Clonburris T1

Amendments Submission

For Proposed Residential Development
Clonburris T1, Co. Dublin

Compliance Submission in Accordance with
Planning Condition no. 3 (Reg. Ref: SDZ21A/022)

Dual Frontage House type (Side Entrance)

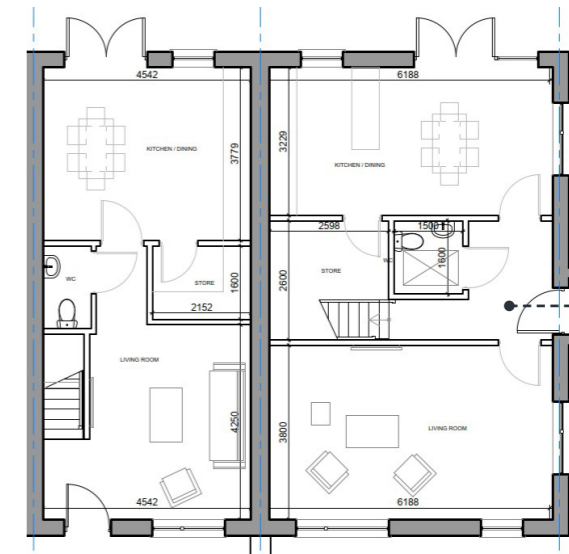
(a) House type 19014 PL 112 Rev A shall be revised to dual frontage. The main frontage shall face the canal

The end house types in the row of units have been revised to address the surrounding streets. The main entrance has been changed to the side so as to create a dual frontage house type. This revision will lend more character and help activate the surrounding road network with footfall and passive surveillance. With the revised layout the end units now benefit from larger living rooms facing out onto the canal. This also aids in providing variety to the linear elevation facing the canal.

Amended Street Elevation

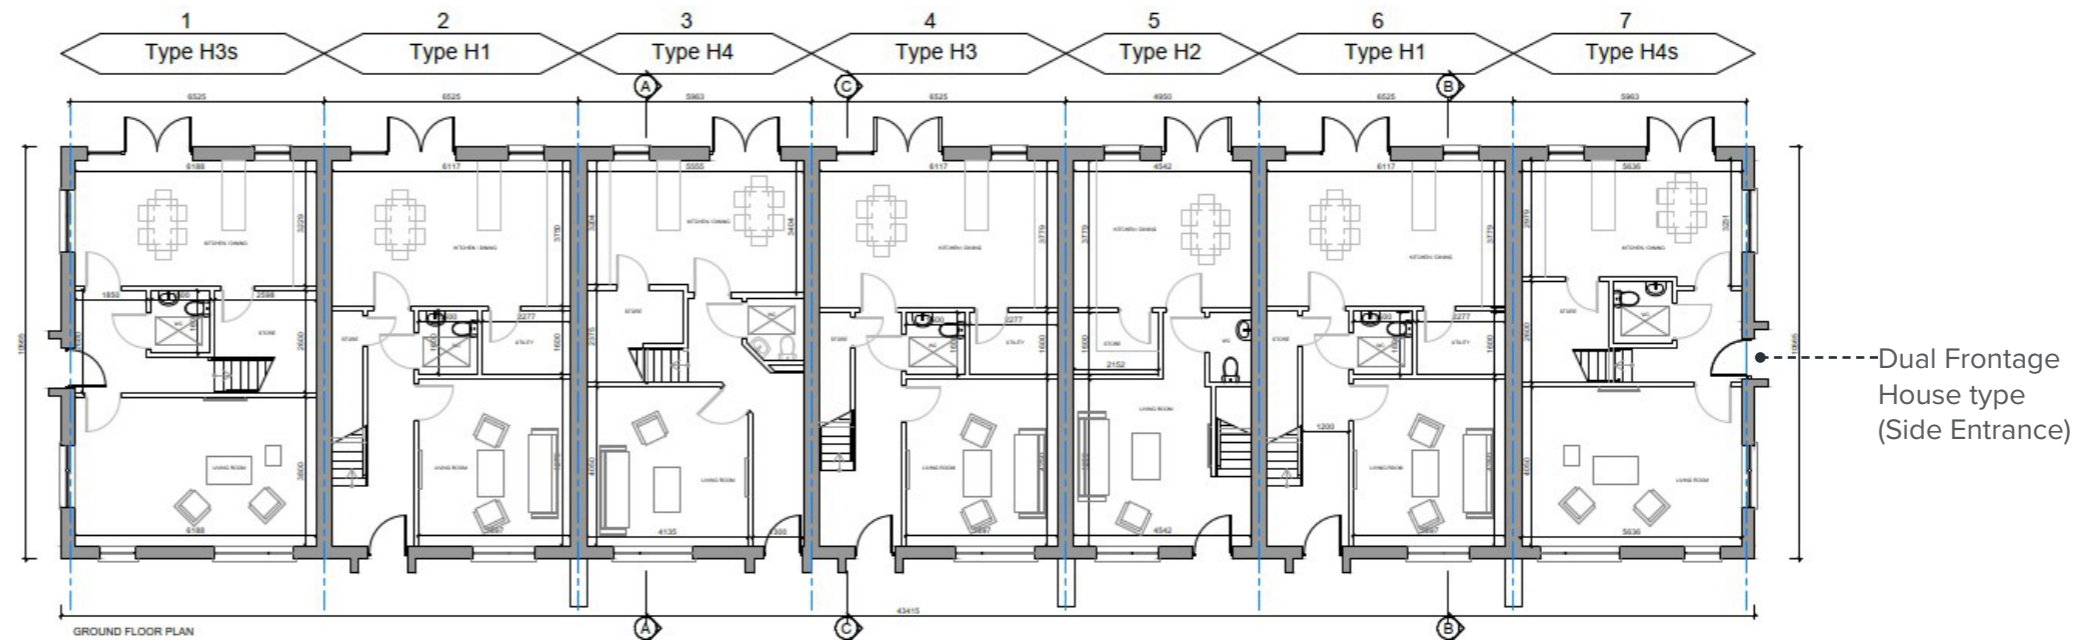
Revised plans that incorporate all of the following amendments-
 (b) House Types H1, H2 shall be revised. Each plot shall have an individual distinctive design, in accordance with Section 2.4.3 of the Planning Scheme.

Having reviewed some of the vernacular typologies around the area and in conjunction with the strategic Development Zone plan we have amended the subject house types to create a more distinctive urban grain.

The material use, ridge pattern and roof profiles of the houses have been revised to create a more varied streetscape combining a more traditional roofscape mixed with a contemporary gable facade.

The two separate Fine Urban Grain blocks located at the east and west ends of the Canal Street have been treated as separate elements to further enhance the variety and character of the site. T18 is located at the east side of Canal Street.

Amended Street Elevation

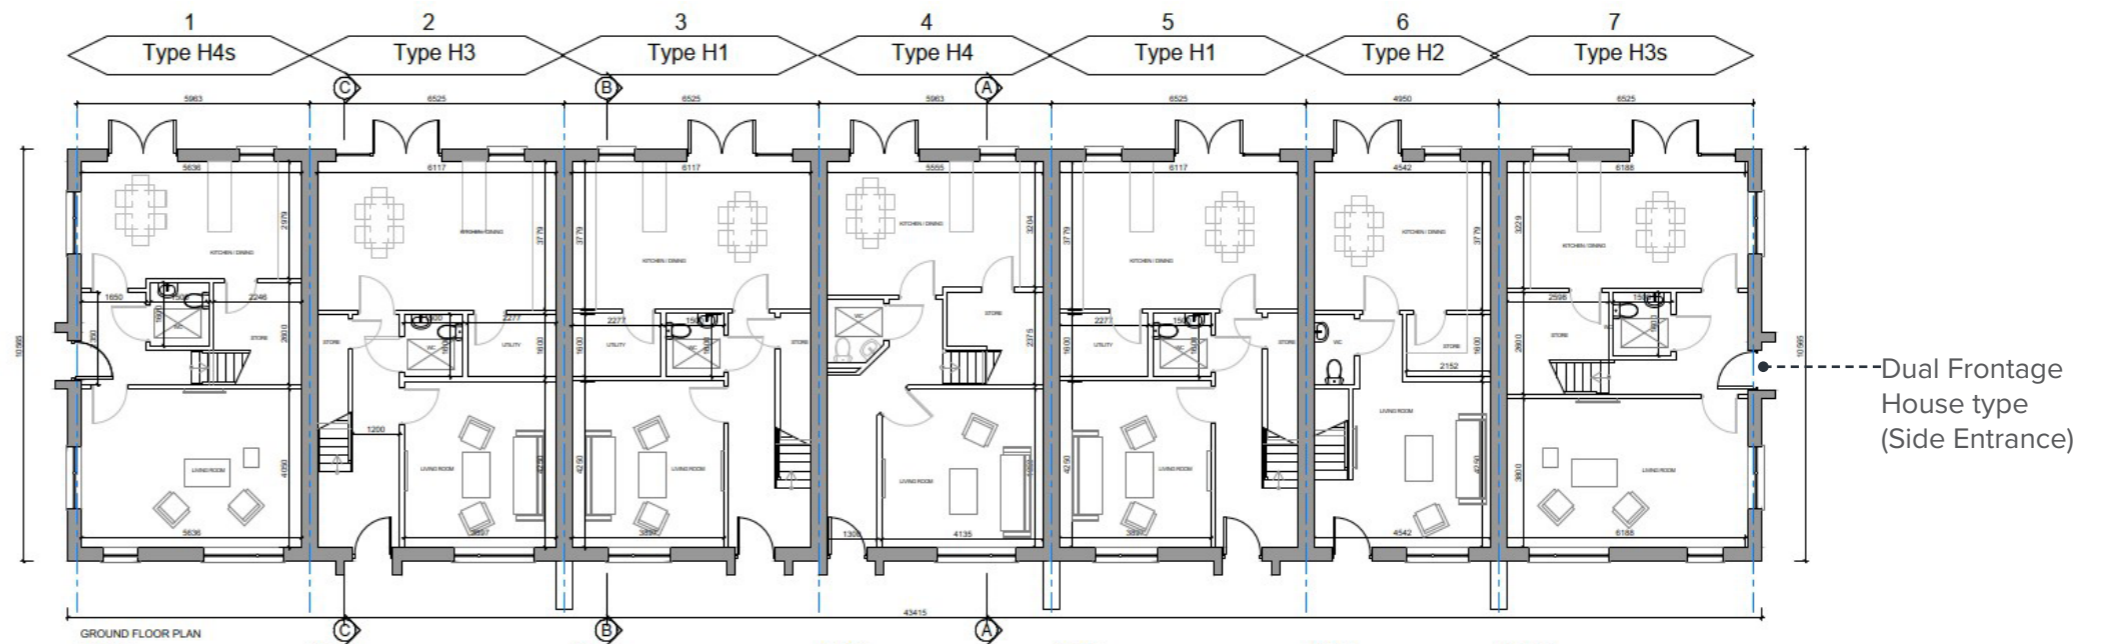
Revised plans that incorporate all of the following amendments-
 (b) House Types H1, H2 shall be revised. Each plot shall have an individual distinctive design, in accordance with Section 2.4.3 of the Planning Scheme.

Having reviewed some of the vernacular typologies around the area and in conjunction with the strategic Development Zone plan we have amended the subject house types to create a more distinctive urban grain.

The material use, ridge pattern and roof profiles of the houses have been revised to create a more varied streetscape combining a more traditional roofscape mixed with a contemporary gable facade.

The two separate Fine Urban Grain blocks located at the east and west ends of the Canal Street have been treated as separate elements to further enhance the variety and character of the site. T21 is located at the east side of Canal Street.
